Subject ▶ Change on ball bearing

For Models ▶ 9520B, 9520, 9520NB, 9521NB and 9522NB

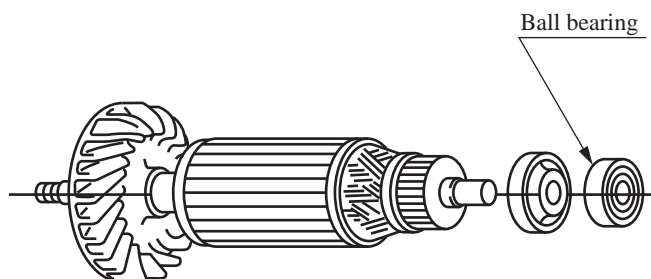
Description ▶ The ball bearing shown in the figure below will be changed from 607LLB (seal color: black) to 607DDW (seal color: green).

Item No.	Current part		Q'ty	I/C	New part		Q'ty	Note
4	Ball bearing 607LLB 211021-9		1	<=	Ball bearing 607DDW 210017-7		1

9520B: From serial No. 15118E
9520: From the next order
9520NB: From serial No. 7706E
9521NB: From serial No. 29641E
9522NB: From serial No. 27510E
